ECE/TRANS/WP.29/GRE/2007/13
28 December 2006

REGULATION No. 37
(Filament lamps)

Provisions for new filament lamp categories

Proposal for draft Supplement 29 to the 03 series of amendments to Regulation No. 37

Figure 1 - Main drawings

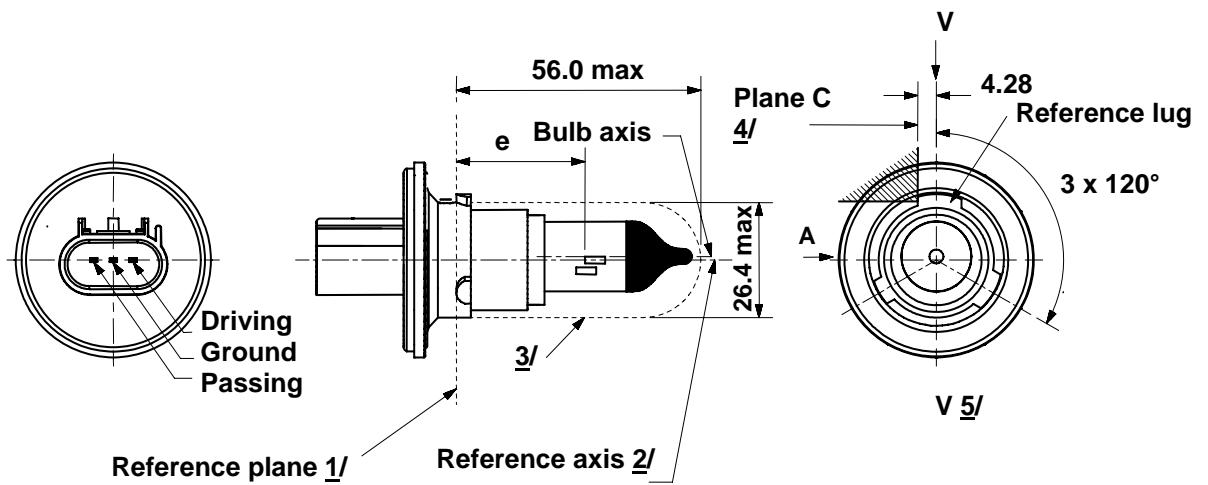
Insert new sheets HS6/1 to 4, between sheet HS5/4 and sheet P13W/1, to read (see next pages):

The drawings are intended only to illustrate the essential dimensions (in mm) of the filament lamp

- 1/ The reference plane is the plane formed by the underside of the three radiused tabs of the cap.
- 2/ The reference axis is perpendicular to the reference plane and crosses the intersection of the two perpendiculars as indicated in Figure 2 on sheet HS6/2.
- 3/ Glass bulb and supports shall not exceed the envelope as indicated. The envelope is concentric to the reference axis.
- 4/ The filament lamp shall be rotated in the measuring holder until the reference lug contacts plane C of the holder.
- 5/ Plane V-V is the plane perpendicular to the reference plane passing through the reference axis and parallel to plane C.

Figure 3
Undistorted area 6/
and opaque coating 7/

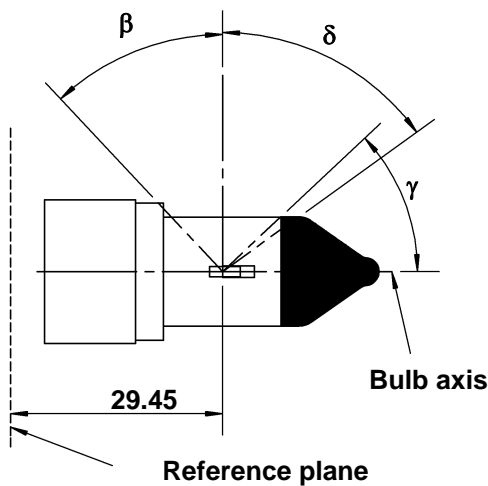
- 6/ Glass bulb shall be optically distortion-free axially and cylindrically within the angles β and δ . This requirement applies to the whole bulb circumference within the angles β and δ and does not need to be verified in the area covered by the opaque coating.

- 7/ The opaque coating shall extend at least to the cylindrical part of the bulb on the whole bulb top circumference. It shall moreover extend at least to a plane parallel to the reference plane where γ crosses the outer bulb surface as shown in Figure 3 (view in direction B as indicated on sheet HS6/1).

Figure 5
Light blocking toward cap 9/

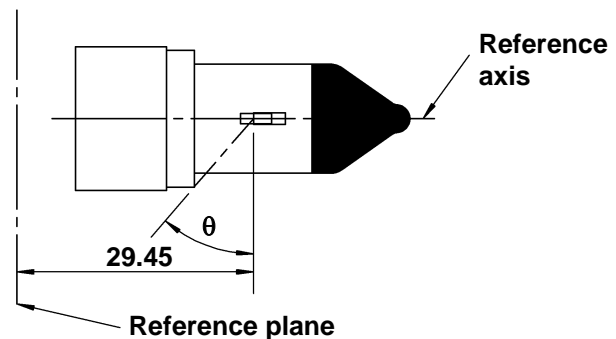
- 9/ Light shall be blocked over the cap end of the bulb extending to angle θ . This requirement applies in all directions around the reference axis.
